RE: 555 Broadwater Road - Buffer Restriction Variance

SITE DEVELOPMENT PLAN
SITE, GRADING & SEDIMENT CONTROL PLAN
BROADWATER BEACH ~ LOT 8
 555 BROADWATER ROAD, ARNOLD, 21012
 TAX ACCT. NO. 03-145-25050108 ~ GP NO. G02018882
 TAX MAP 0033 GRID 0013 PARCEL 0018 DISTRICT 3RD
 ANNE ARUNDEL COUNTY, MARYLAND

Project Name (site name, subdivision name, or other) Burt Residence Pool Relocation

CONFIRMATION OF PRE-FILE MEETING

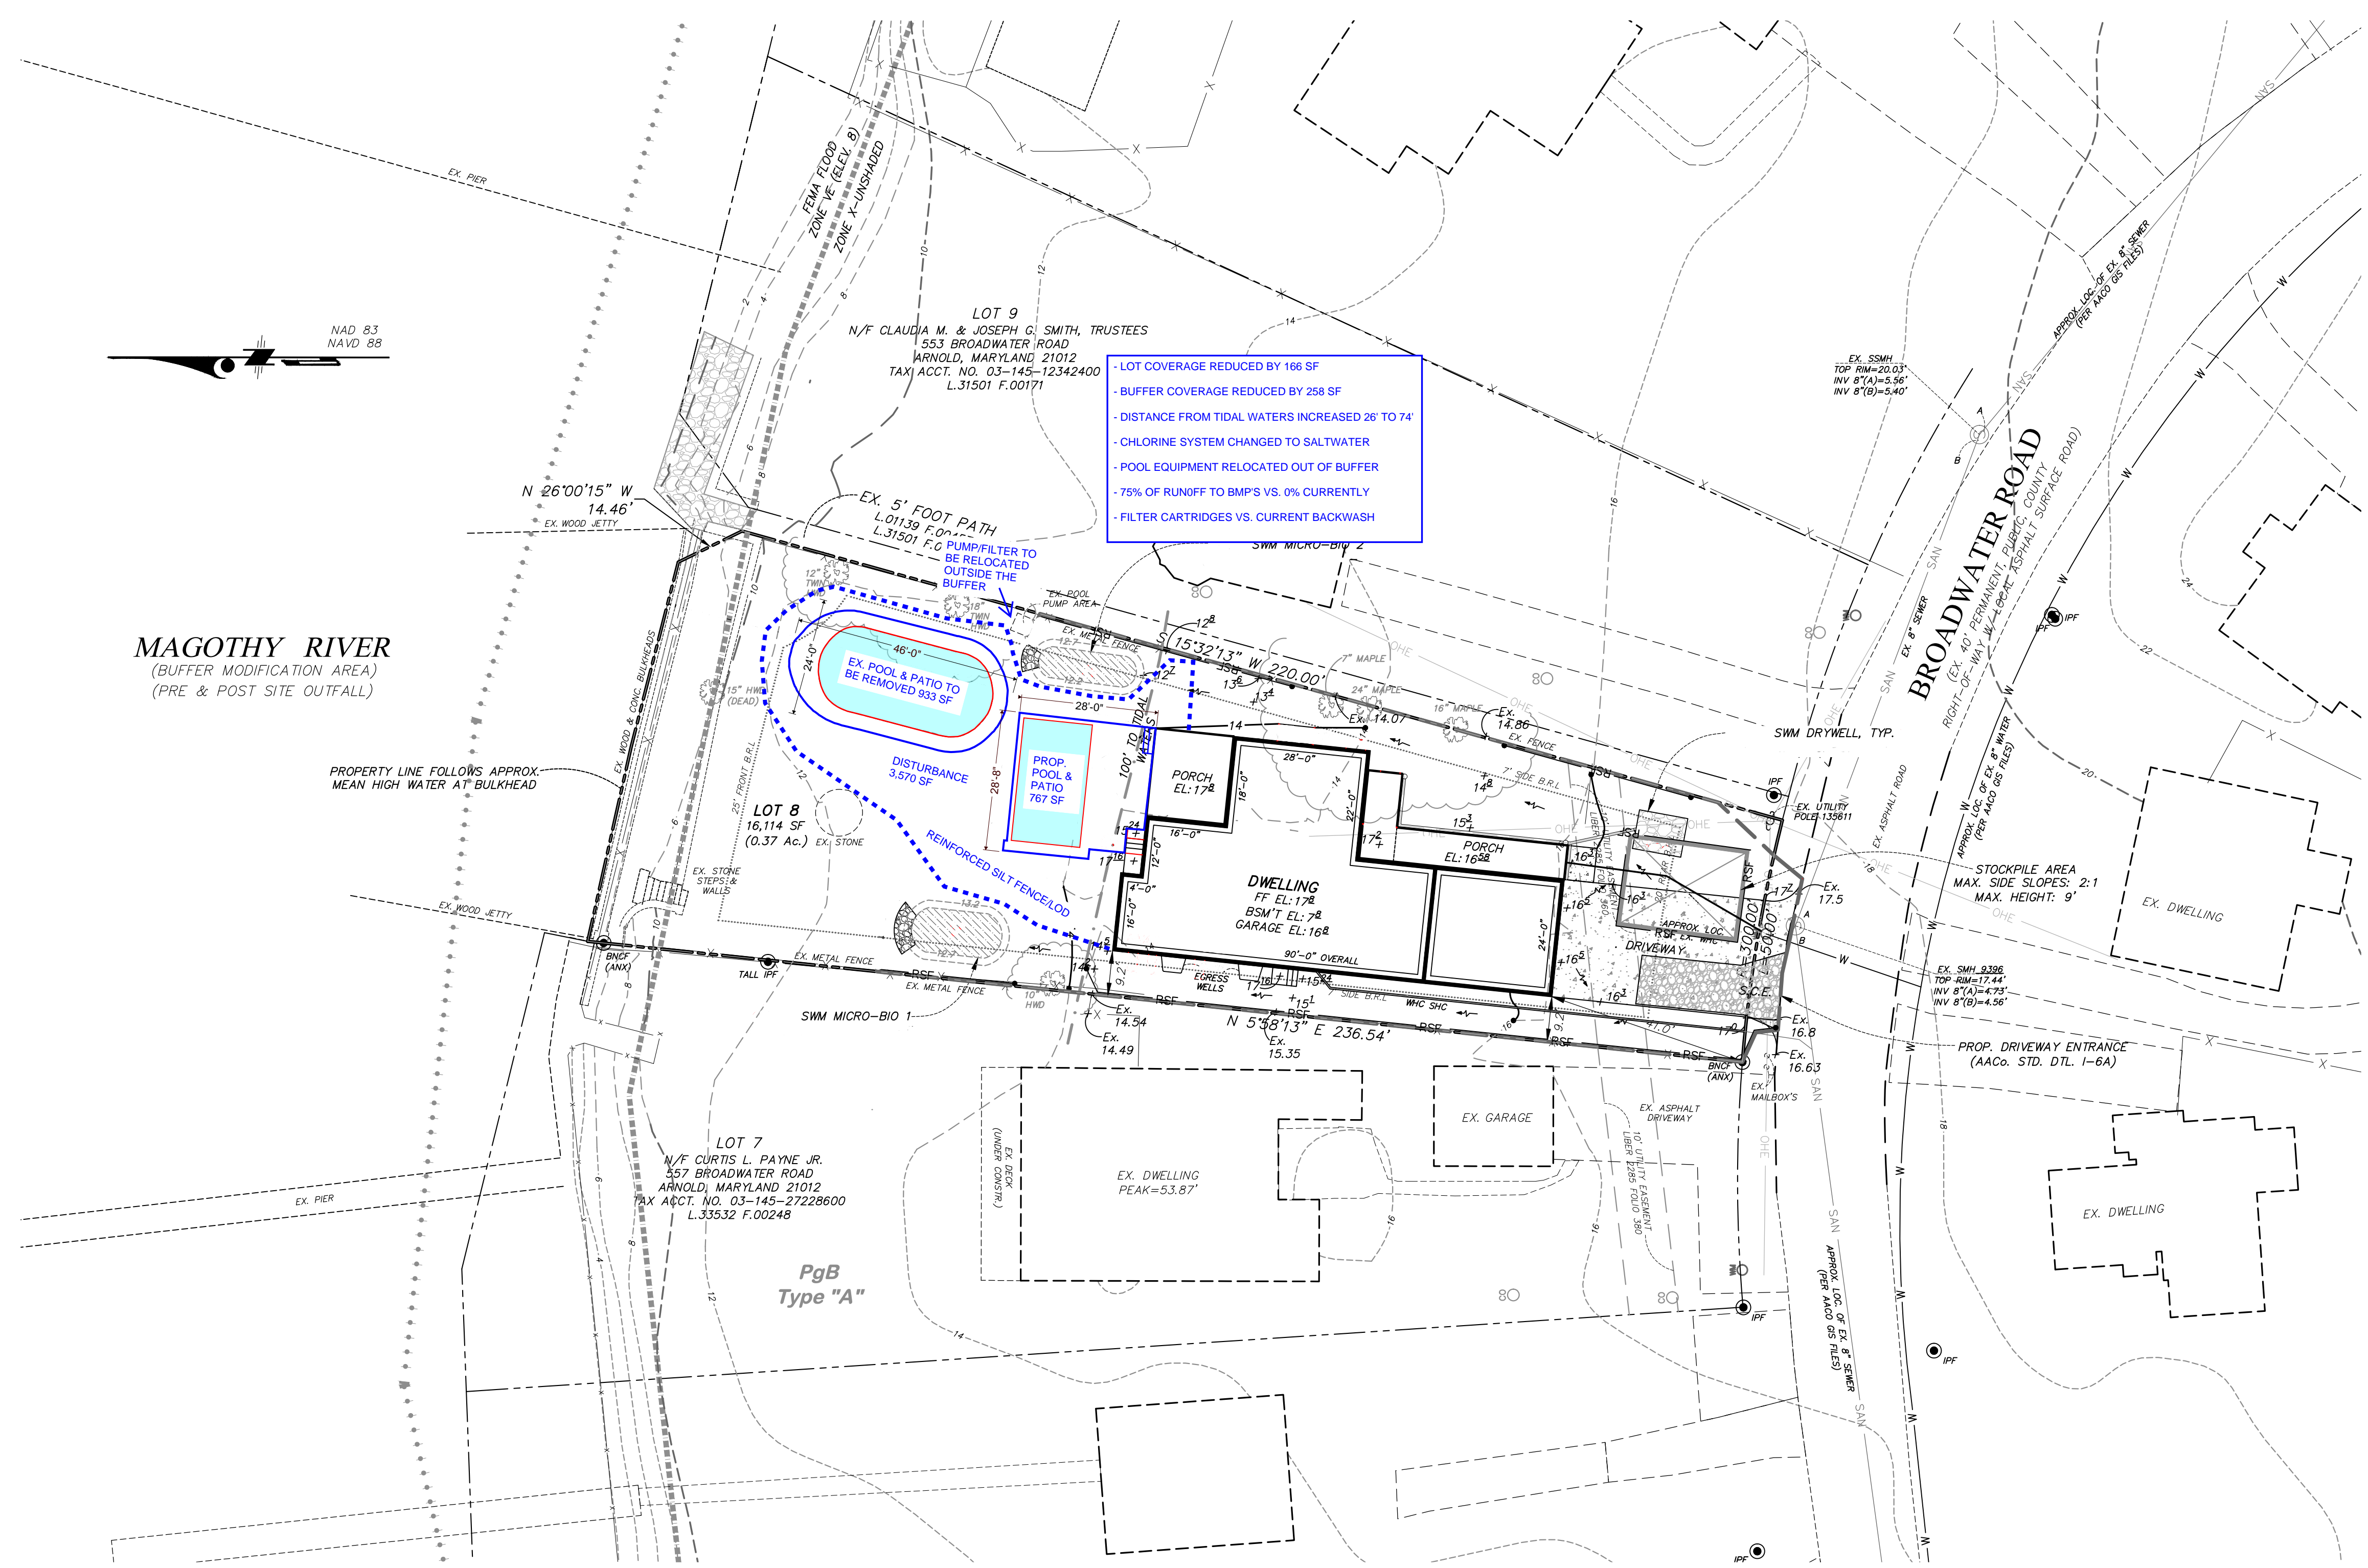
Critical Area Team - The Critical Area Team offers no objection to the relocation of the pool further from the shoreline. Based on the numbers submitted with this plan, the relocation will result in additional coverage in the buffer. While the CA Team can support the relocation, we will not support additional coverage forward of the front facade of the existing home.

Zoning – Site Plan appears to meet info requirements. Request is subject to criteria for granting a variance. Ref 18-16-305 of the AA County Code
